REMARKS

Amendments to the Drawings:

FIG. 1

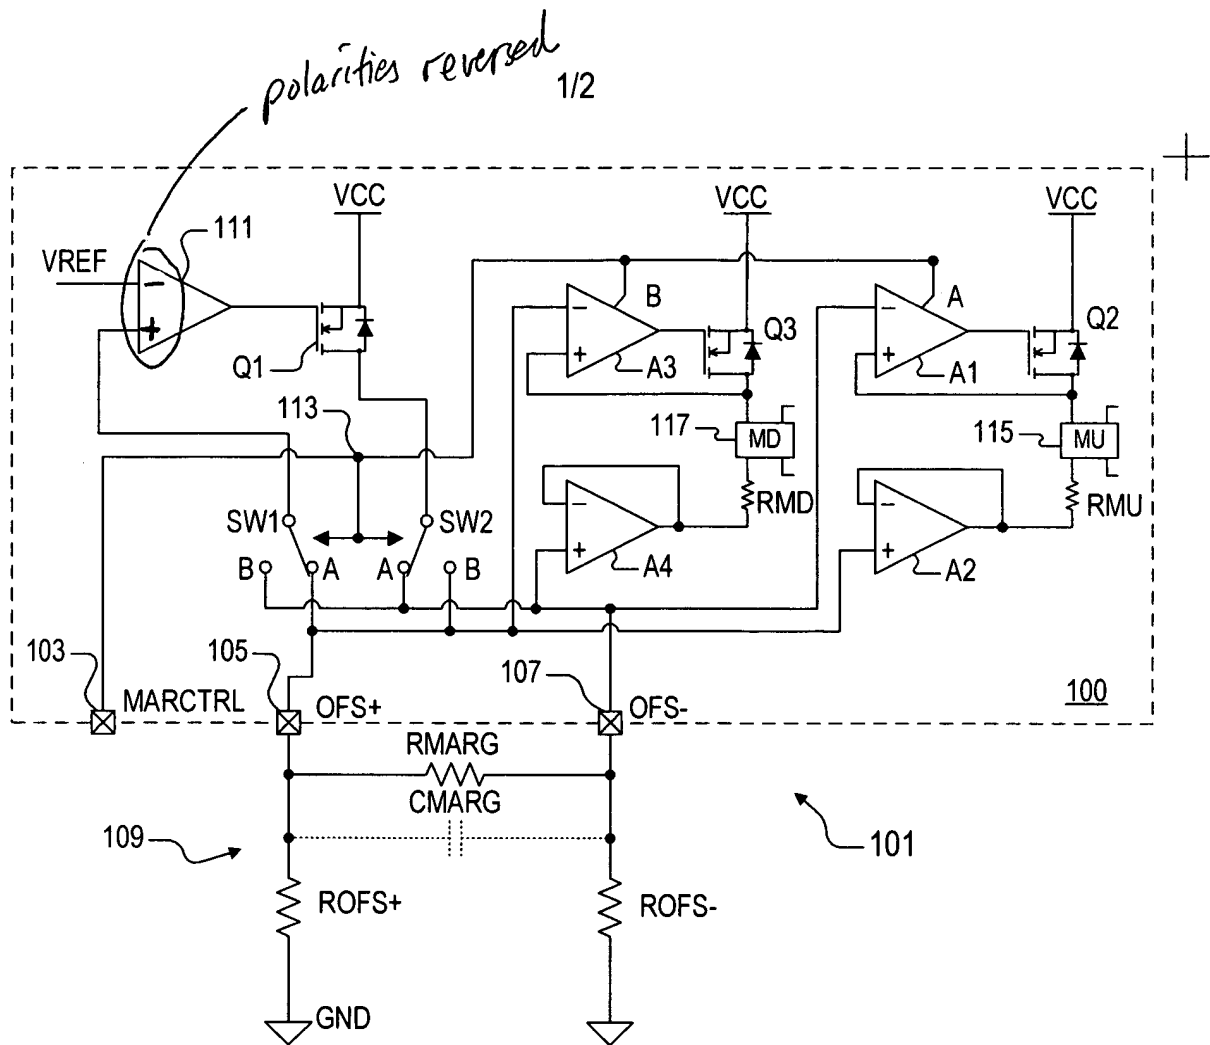
In the application as filed, the input polarities of the amplifier 111 of FIG. 1 were inadvertently reversed. The VREF signal was intended to be provided to the inverting input (e.g., the “-” or negative input) of the amplifier 111 rather than to its non-inverting input (e.g., the “+” or positive input). Also, the non-inverting input of the amplifier 111 was intended to be connected to the common pole of the switch SW1 rather than the inverting input of the amplifier 111. A replacement sheet for FIGS 1 and 2 is attached hereto including FIG. 1 with the input polarities of the amplifier 111 reversed. An annotated sheet is also attached herewith which shows the change and a brief description of the change in red.

The attached sheet of drawings includes changes to FIG. 1. The replacement sheet, which includes FIGS 1 and 2, replaces the original sheet including FIGS 1 and 2. The annotated sheet shows, in FIG. 1, the change in which the polarities of the inputs of the amplifier 111 are reversed.

Also, original paragraph [0024] of the application as filed is replaced with an amended paragraph, which is substantially the same as the original paragraph except that the references of the inverting and non-inverting inputs of the amplifier 111 are swapped to correspond with the proposed amendment to FIG. 1. Applicant respectfully submits that this polarity reversal was a typographical error when translating the Figures and that one skilled in the art would understand
